Document ID: IK0400125

Title: Rear S Cam Tube/ Bracket part update

Applies To: Prostar, CAT, LoneStar, Durastar, WorkStar, TranStar

Figure #1: Cam Tube

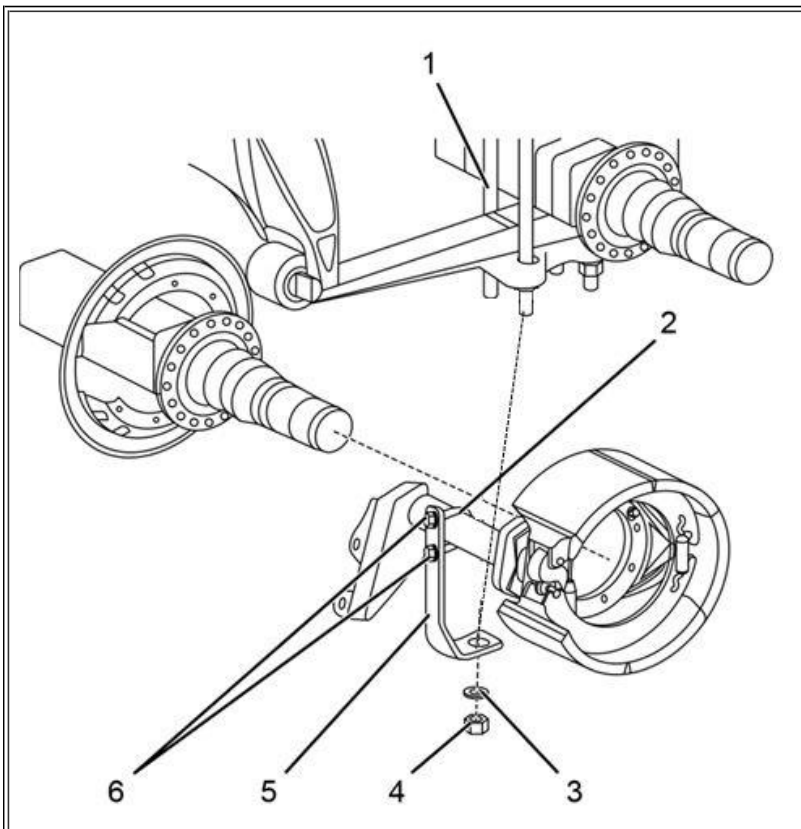
NOTE: On certain wide base axle applications the new SCAM gusseted bracket will come into contact with the old support brackets. It will be necessary to order and relocate new s-cam Support bracket to the out board side of the U-bolt (Bolt closest the wheel).

1. Remove and discard old support bracket

2. Remove Out Board U-Bolt Nut

- a. Slide new cam tube support bracket (Figure 1, Item 5) over the out board U-bolt (Figure 1, Item1)
- b. Position exhaust pipe clamp (Figure 2, Item 2) on cam tube support bracket (Figure 2, Item 5) and through cam tube support bracket slots with two washers and nuts

Figure # 2: Support Bracket

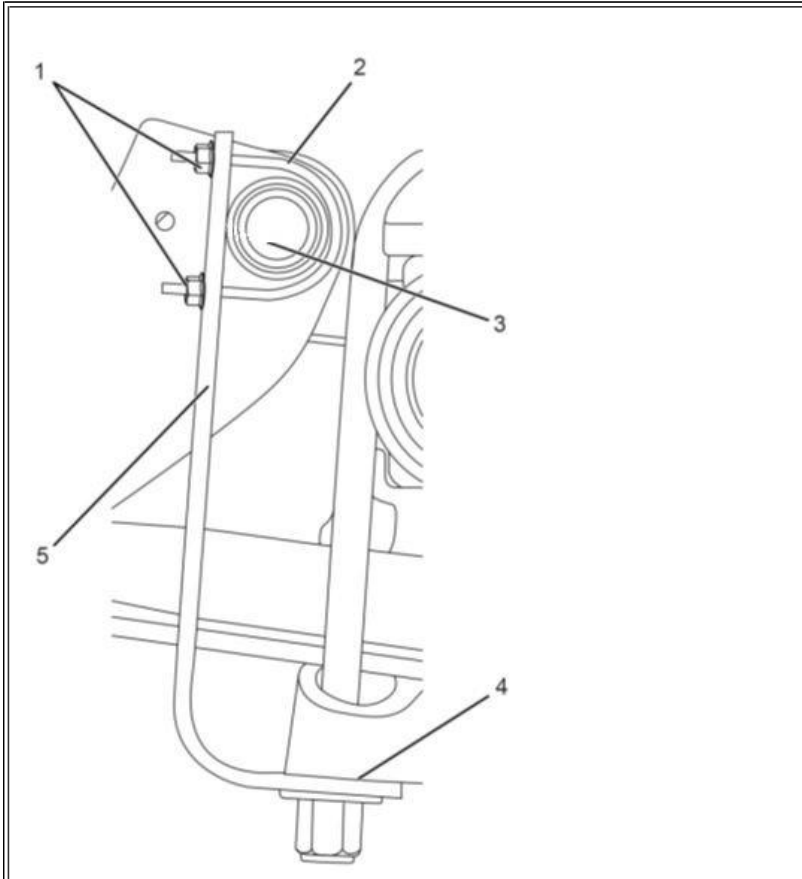
(Figure 2, Item 1) hand tight.

c. Ensure cam tube support bracket (Figure 2, Item 5) is contacting cam tube (Figure 2, Item 3) and is sitting flush against rear U-bolt spring plate (Figure 2, Item 4).

d. Using torque wrench, tighten two nuts (Figure 2, Item 1) to 60 - 72 lb-in (6.8 - 8.1 N•m).
